# **THE STAR MODIFICATION 14 (MP 08\_0098)**

## **HERITAGE RESPONSE TO COMMENTS**

Figure 6 – Extract from proposed ground floor plan to SELS.

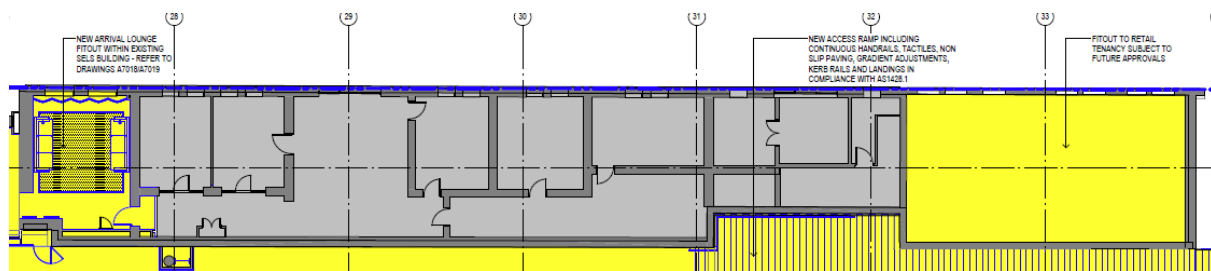
**(Refer Section 3.1 below for discussion).**
- *Fitout to the retail tenancy in the SELS Building is subject to “future detail” and should be the subject of a separate DA.*

Any fitout to the tenancy will be the responsibility of the future tenants and will be addressed as part of a future applications. Under this application, it is proposed only to remove the existing contemporary fitout. This will have no heritage impact.

Figure 8 – Extract from VIP Lounge Plan.

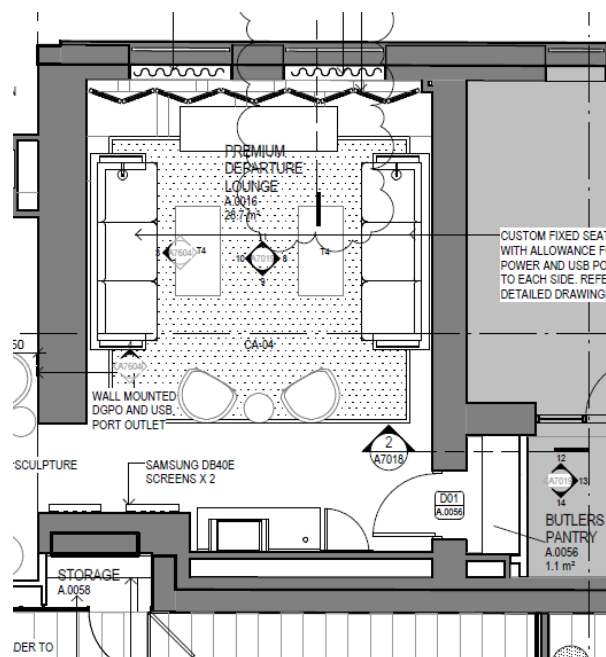
**(Refer Section 3.6 below for discussion).**
- *With regard to the arrival lounge, the demolition plan is unreadable and the proposed changes are difficult to decipher. Clear detail of the demolition and the changes being proposed should be shown on the drawings, including section, which should include the extent of demolition, lightweight construction of the new partition for the butler’s pantry and other changes to the room layout, removal of the suspended ceiling, details of screening etc.*

The demolition plan has been provided at a scale of 1:100@A1 and the new works have been represented in revised drawings.

In summary, the proposal requires the demolition of later fabric including partition walls and suspended ceiling. Allowance is made for the retention of any original flooring or ceilings found during the works behind the proposed finishes/ceiling.

The new works largely include the addition of freestanding furniture into the room. The new butler's pantry would be lightweight and would not obscure the significant original door to the adjacent room.

The new ceiling would be at an appropriate height which would clear the head height of the windows and their detail on the western wall.

The Butler's Pantry would be constructed of lightweight reversible partitions (refer 303448\_A7018 prepared by DWP Suters).

The new awnings would fit within the existing arched brick recesses (refer 303448\_A7018 prepared by DWP Suters).

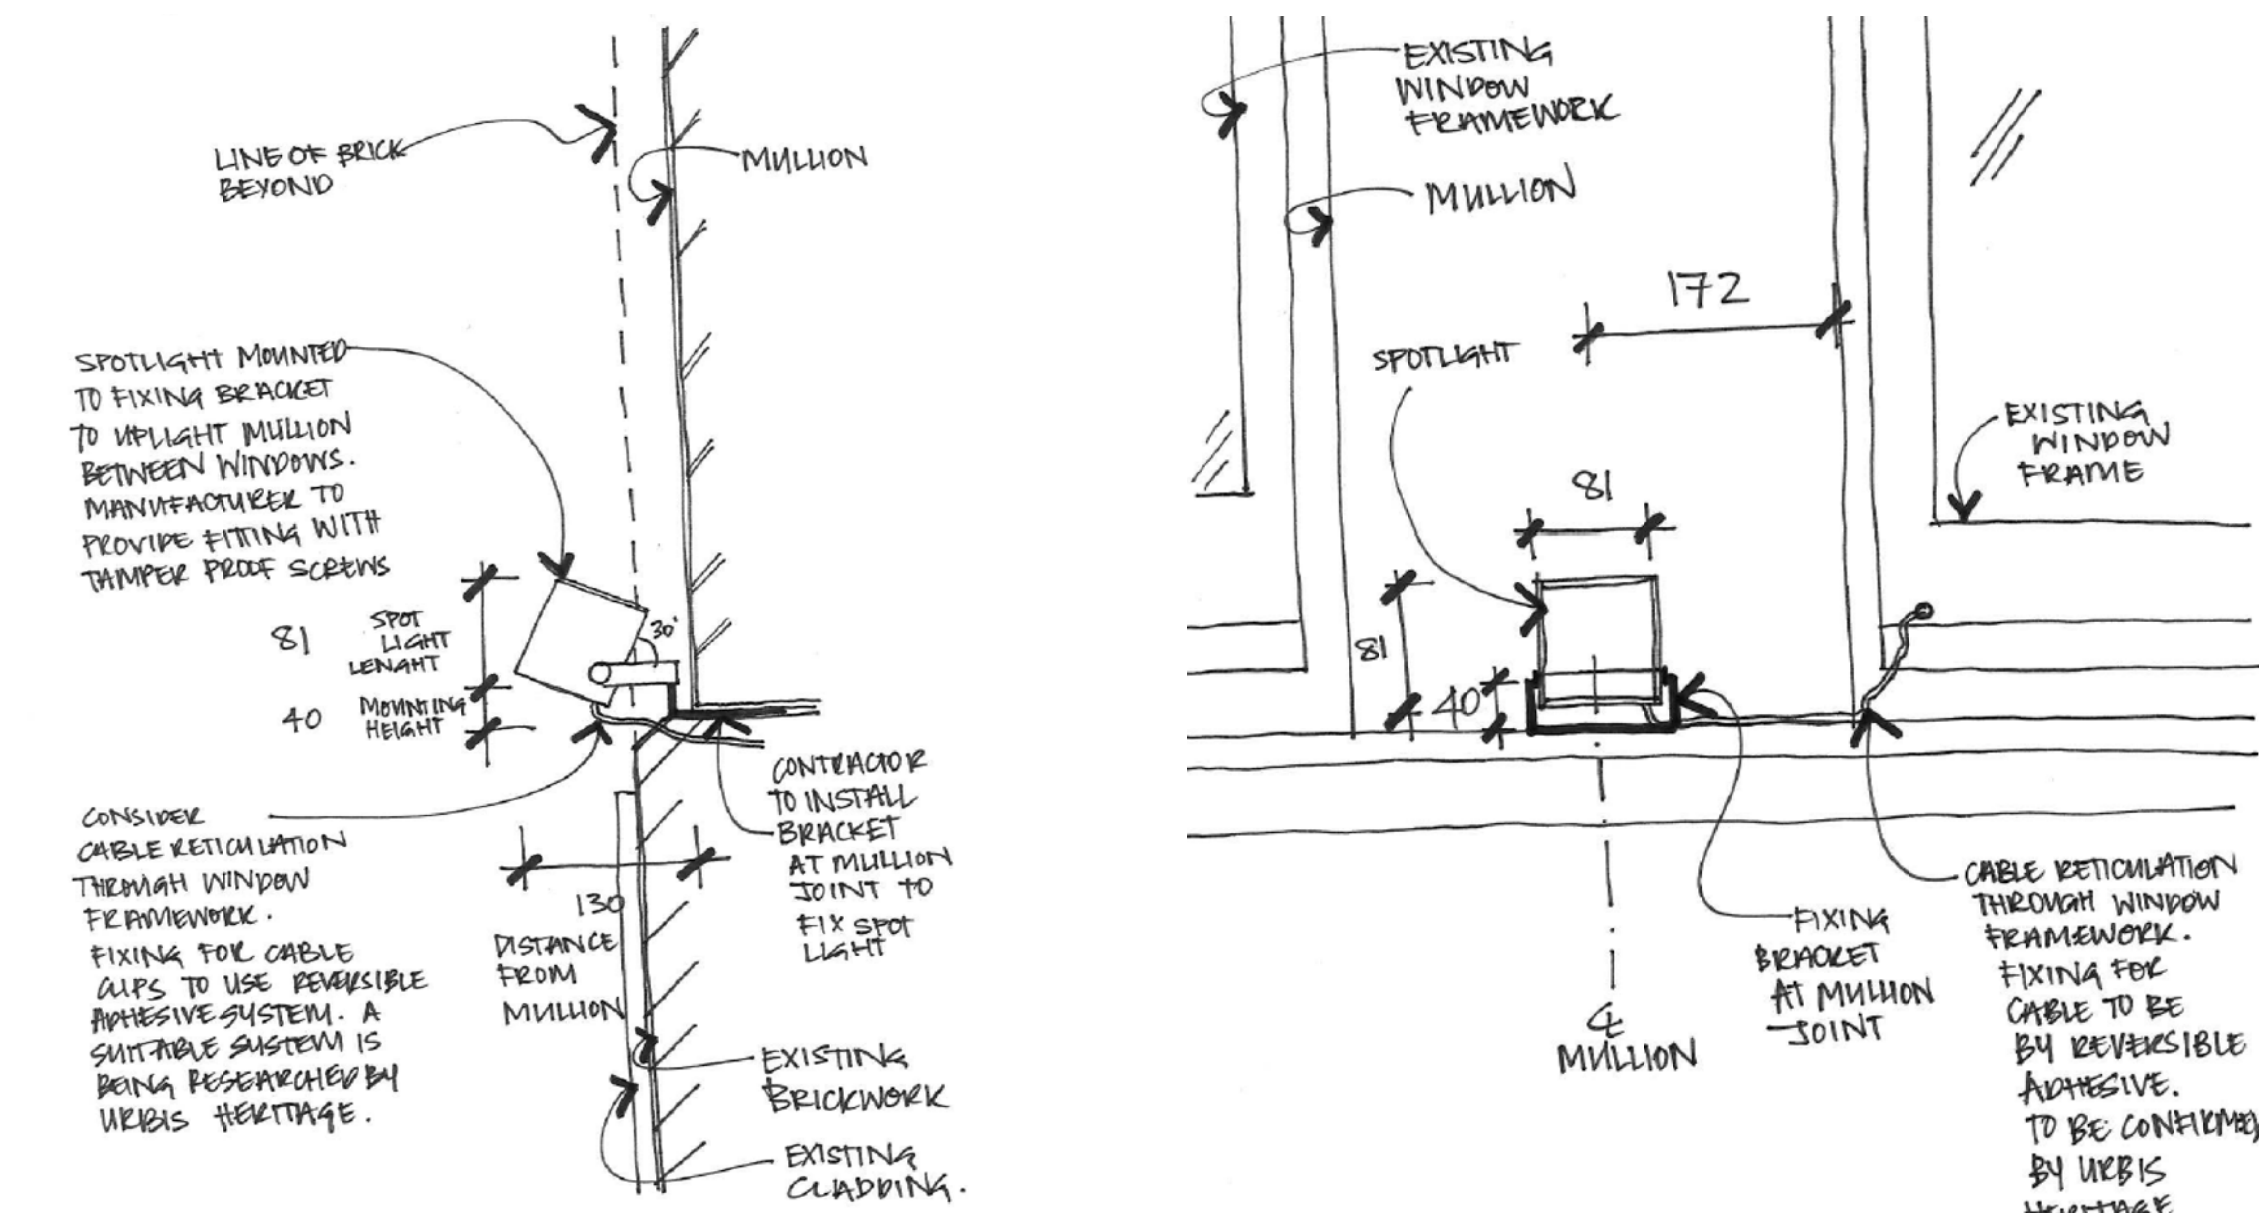
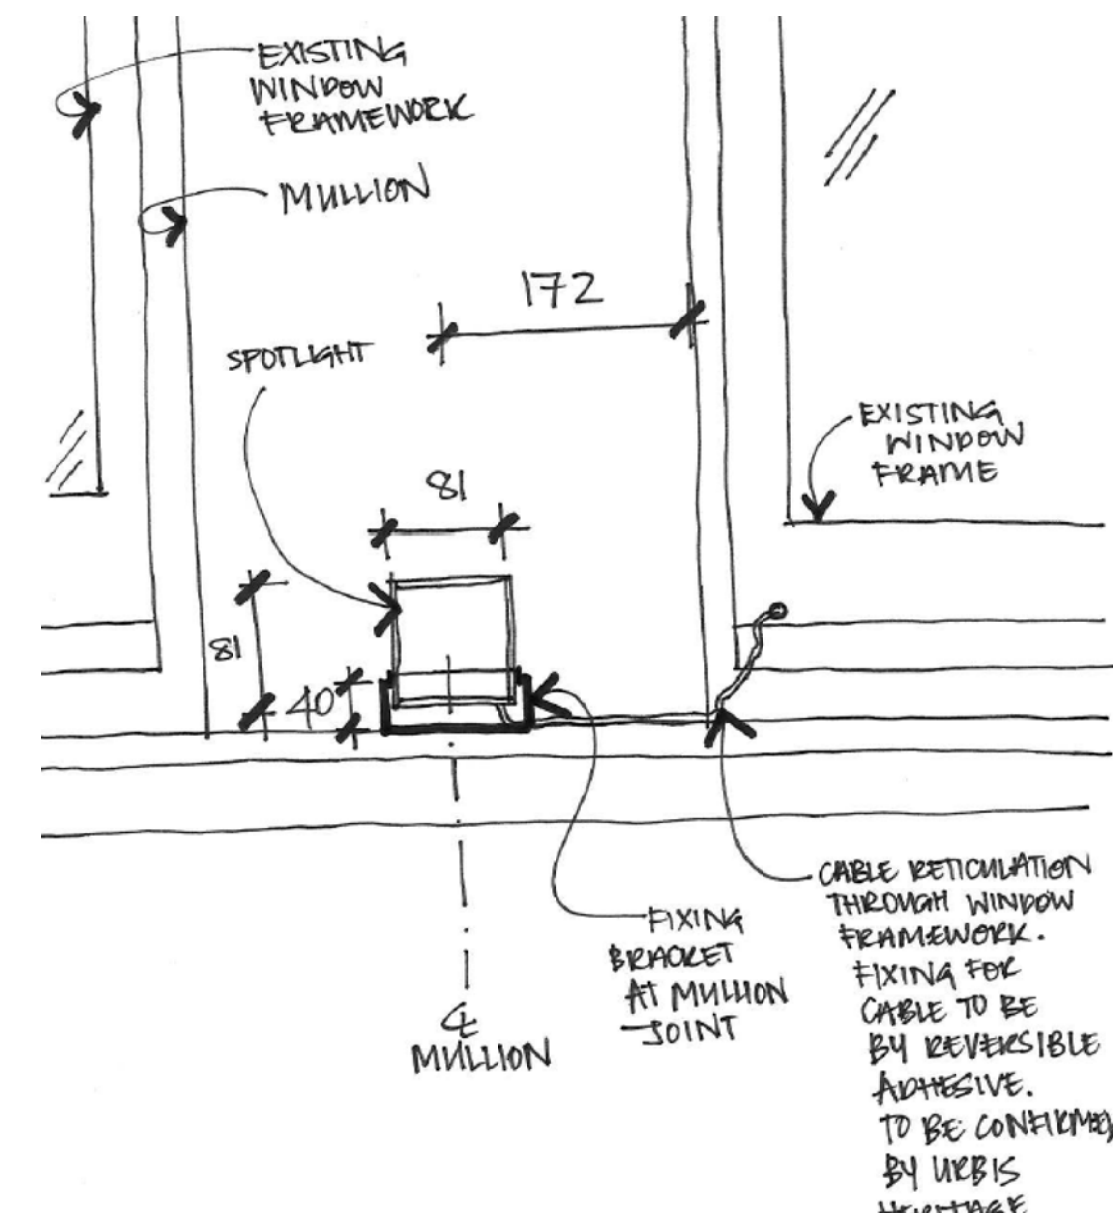
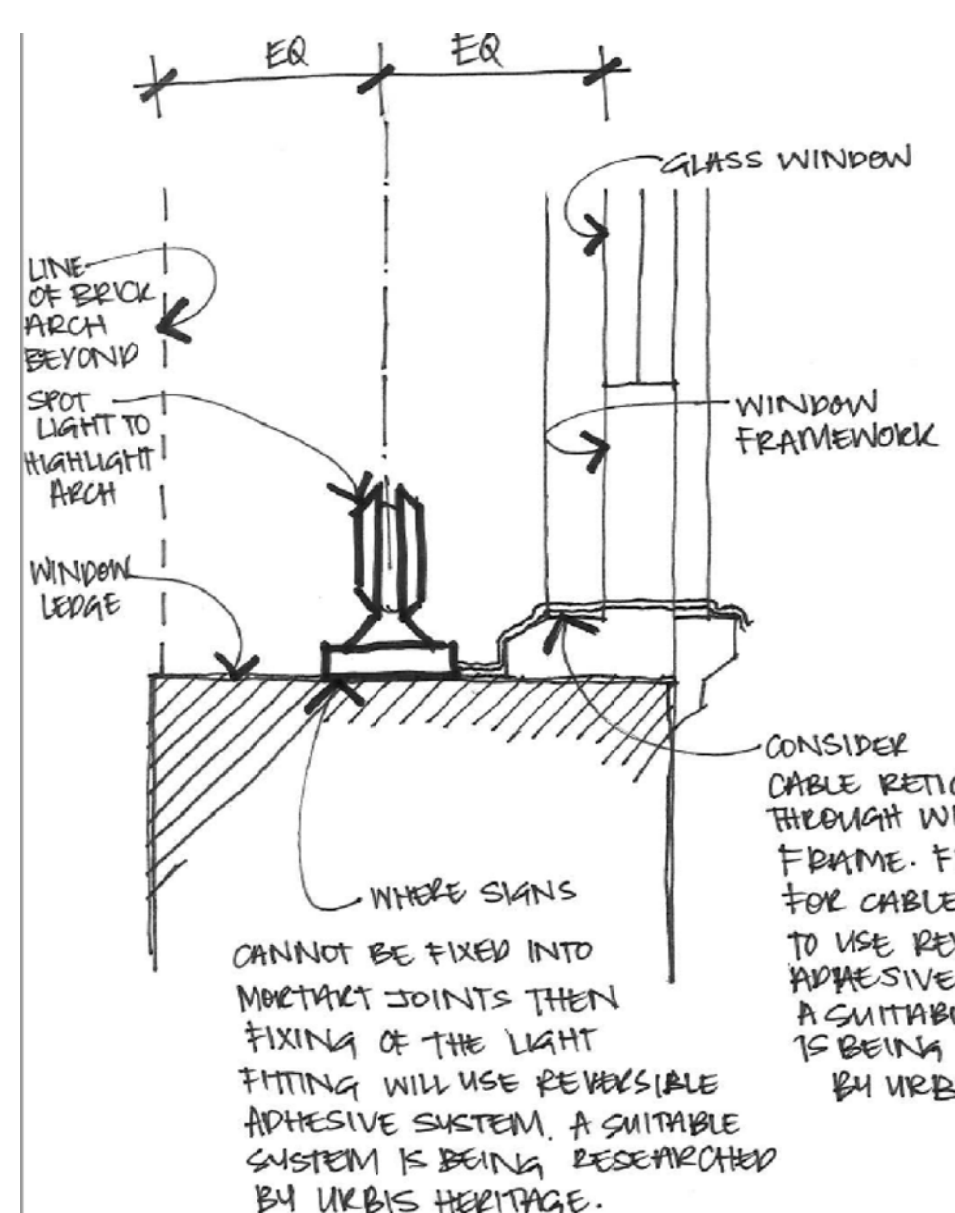
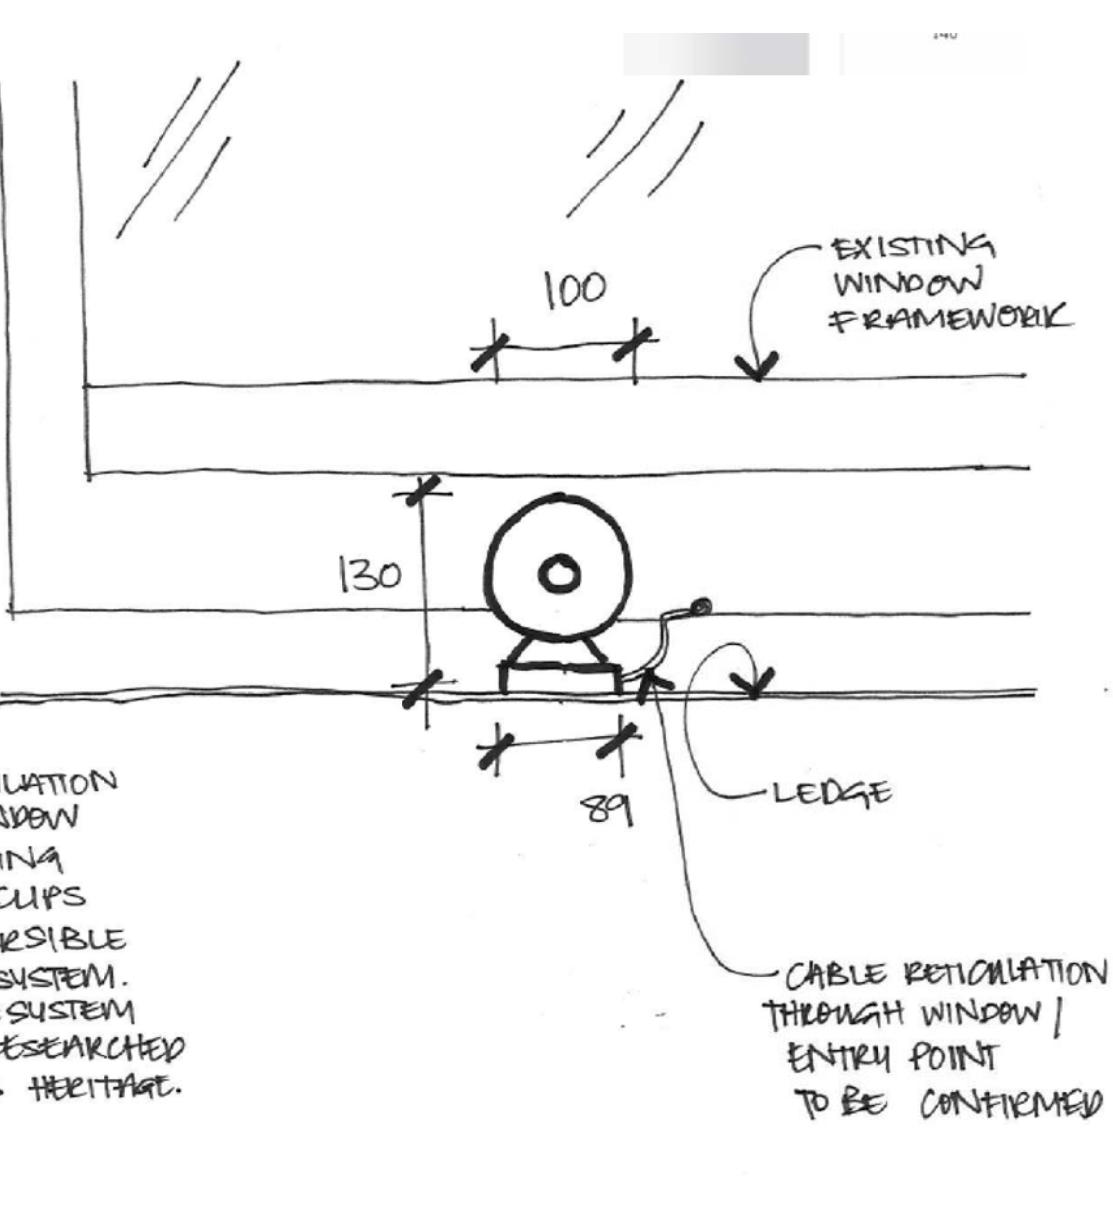
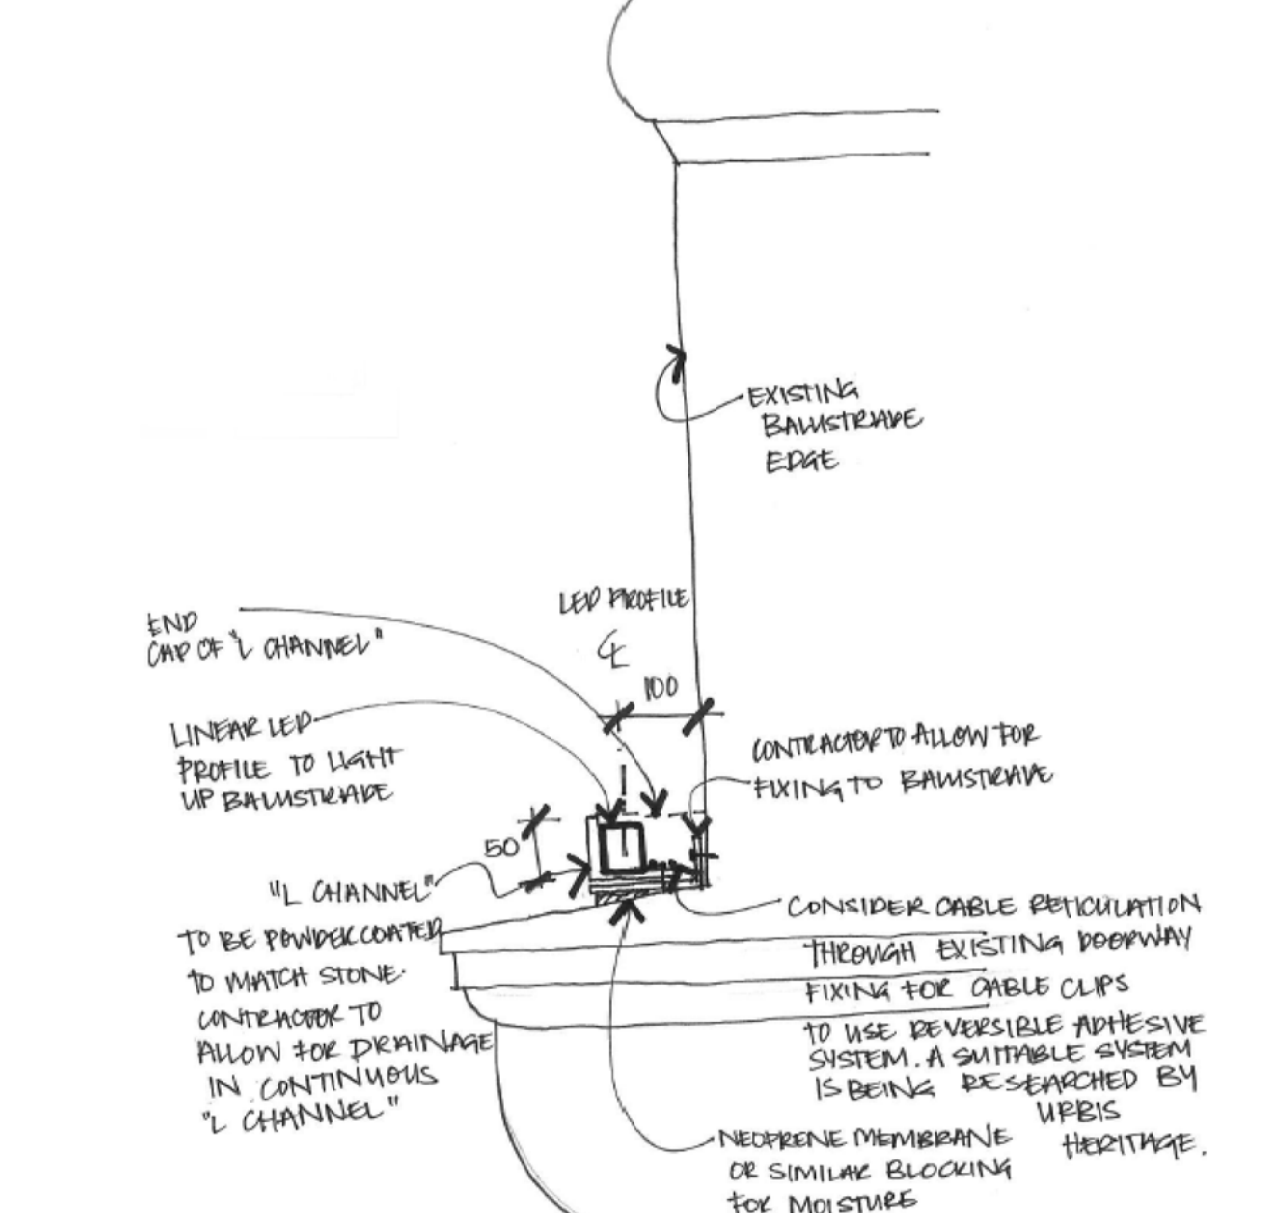
**(Refer Section 2.1 below for discussion).**
- *Any proposed changes to the external lighting to The SELS building should be in keeping with the recommendations made in the Heritage Impact Statement report, by URBIS Pty Ltd. In addition, a mock-up of the proposed lighting effects to the The SELS building should be organised, on site, to be inspected and approved by a suitably qualified heritage consultant.*

**(Refer Section 3.5 below for discussion).**
- *In relation to proposed lighting to the Pyrmont Street façade of the SELS Building, the report by Point of View includes a drawing “to convey design intent only” but the details are not shown on the submitted plans.*

The accompanying drawings have been provided as a mock up of the proposed lighting to The SELS. The lighting has been developed in accordance with the Dialux Render provided in Mod 14, the recommendations set down in the HIS by Urbis and with ongoing consultation with Urbis.

A methodology has been prepared by Urbis in collaboration with Point of View to ensure the appropriate treatment of the heritage item. In summary, the lighting strategy methodology ensures that the proposed strategy avoids penetrations into brick and stone fabric, and minimises the sizes of any penetrations through other fabric. The methodology statement also aims to minimise the visual impact of the light fittings and cabling.
